# UNITED STATES PATENT AND TRADEMARK OFFICE

<b>Office Action Summary</b>	<b>Application No.</b> 10/573,003	<b>Applicant(s)</b> MERLO ET AL.	
	<b>Examiner</b> MARIA J. LAIOS	<b>Art Unit</b> 1795

## **DETAILED ACTION**

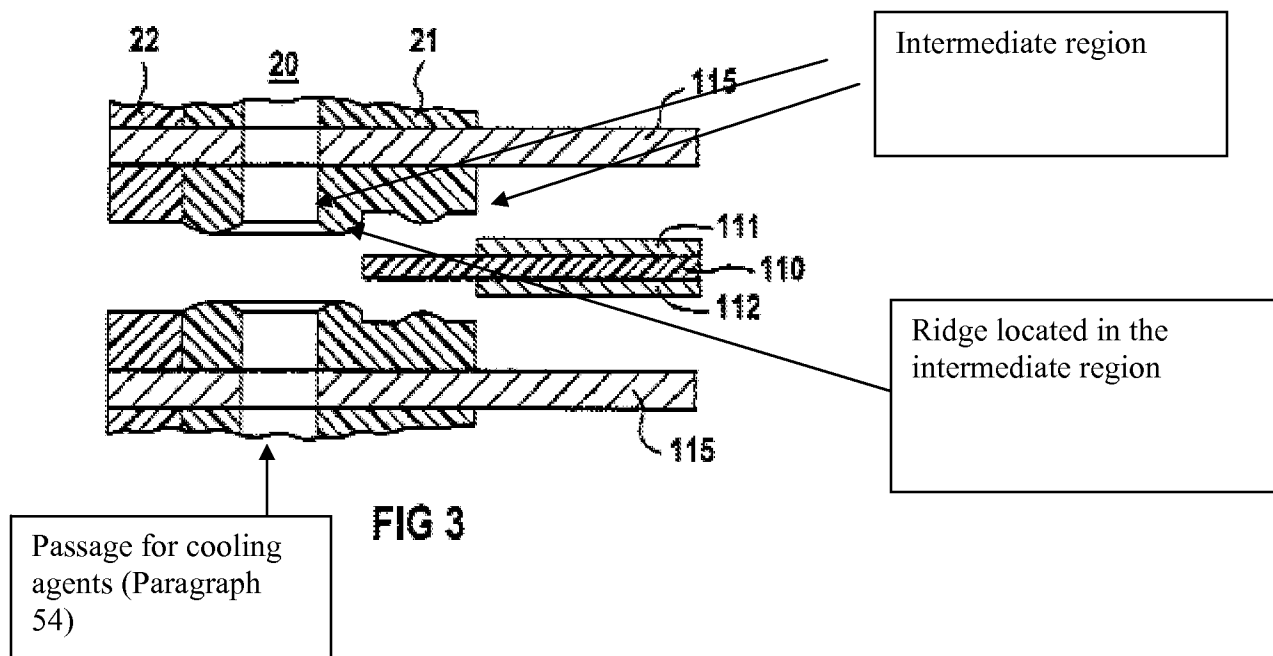
Faita modified by the Applicant fail to disclose the edge of the membrane in the intermediate region defined by the boundary of the center hollow portion in the gasket and the circumference of the passage openings. Baldauf et al. disclose a fuel cell stack with a gasket and a membrane. Baldauf discloses the perimeter of the membrane (110) in the intermediate region (see figure below)

It would have been obvious to one of ordinary skill in the art at the time of the invention in include the seals of Baldauf in the fuel cell system of Faita modified by Admitted Prior art because this would prevent the interaction of the fluids traveling through passages with the membrane.
